Palo Verde Nuclear
Generating Station

**Subject: Palo Verde Nuclear Generating Station (PVNGS)
Unit 1
Docket No. STN 50-528
Response to Request for Additional Information
Relief Request No. 46**

**Response to Request for Additional Information
Relief Request No. 46**

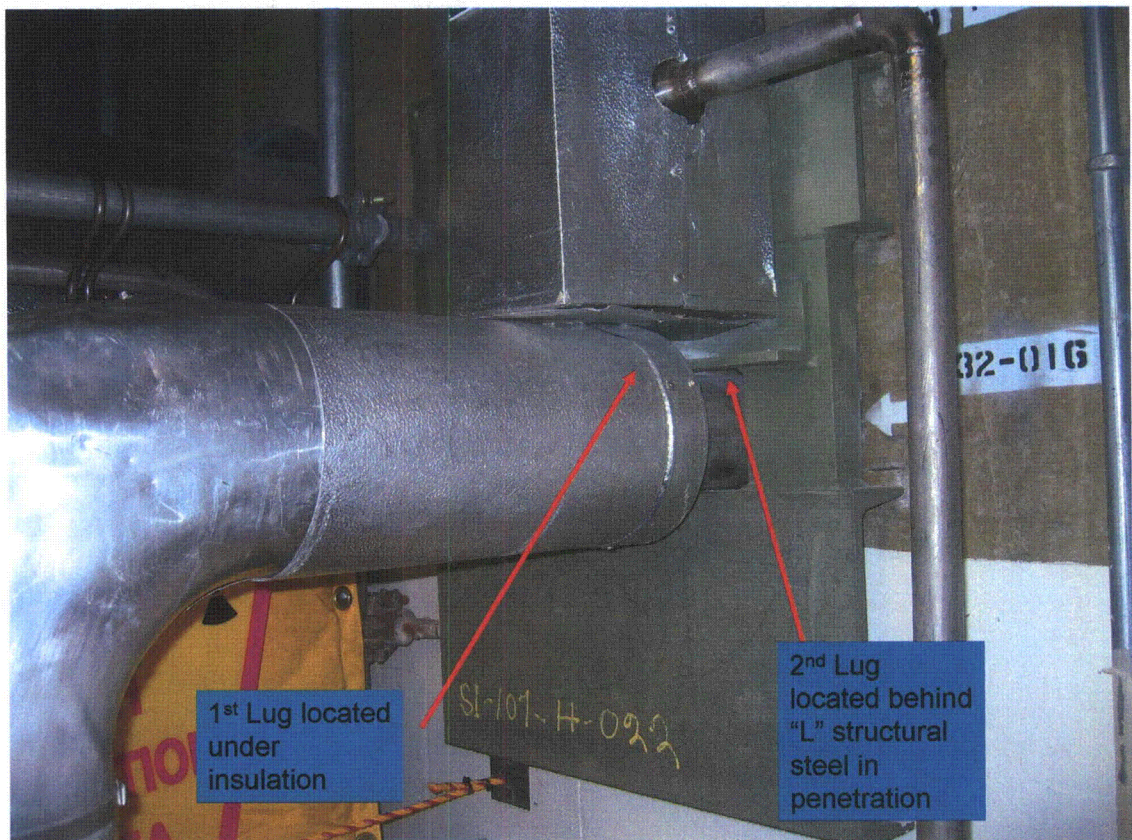
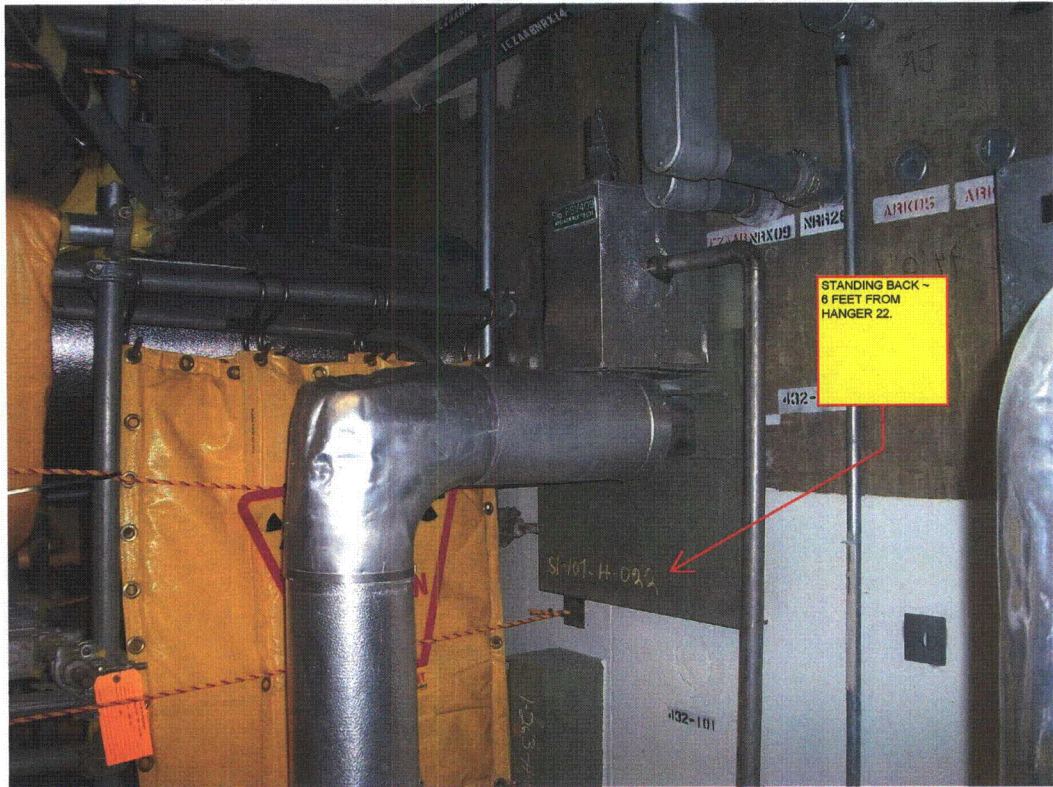
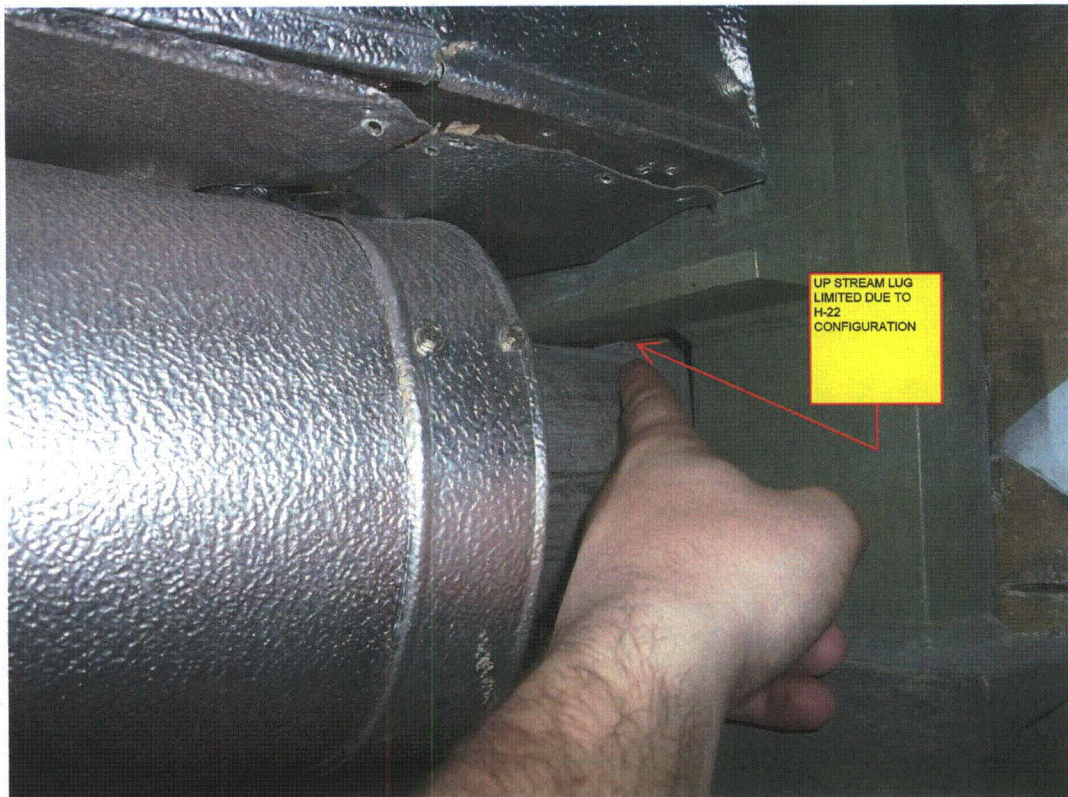
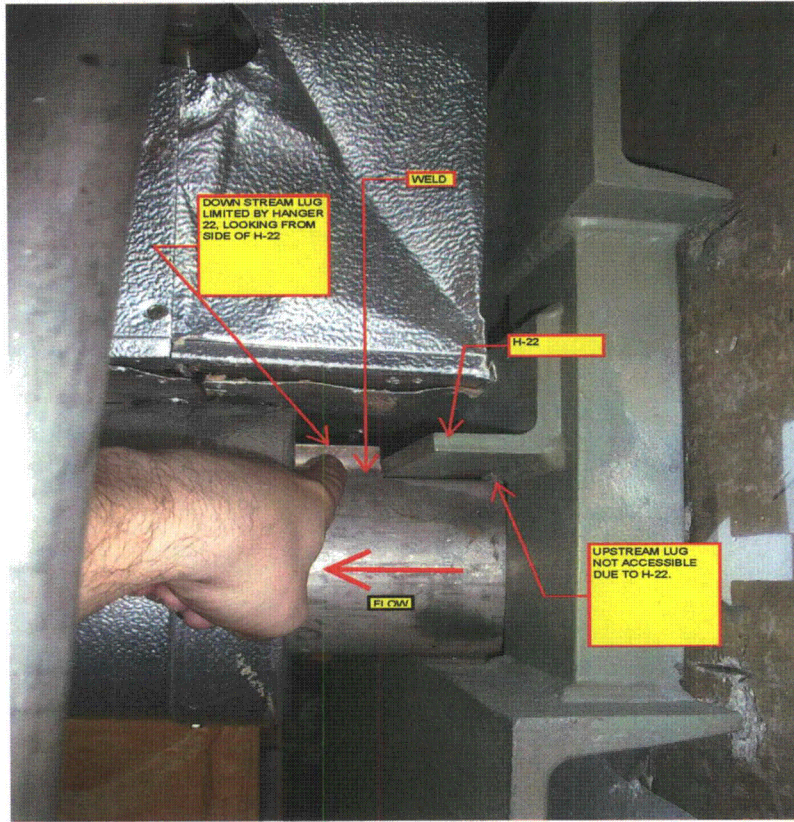
In part "D" of RR 46, the licensee stated that the surface examinations of ASME Code, Section XI, Examination Category C-C piping support attachment welds could not achieve the ASME Code-required coverages. Please provide more detail on the extent of coverage that was obtained for each Category C-C weld identified in the submittal and discuss the results of these surface examinations, including whether any relevant indications were found during these examinations.

As shown in the following photographs, support SI-107-H22 contains two lugs welded to the 12 o'clock position on the piping. One lug (upstream lug) is completely inaccessible because it is located behind the structural member of the support. The inspection coverage on this lug was 0.0 percent. The downstream lug has one end butting up against the structural member making this end inaccessible. As a result, approximately 83 percent coverage was obtained on this lug for a total of 41.5 percent coverage on both lugs. No relevant indications were found during the examination.
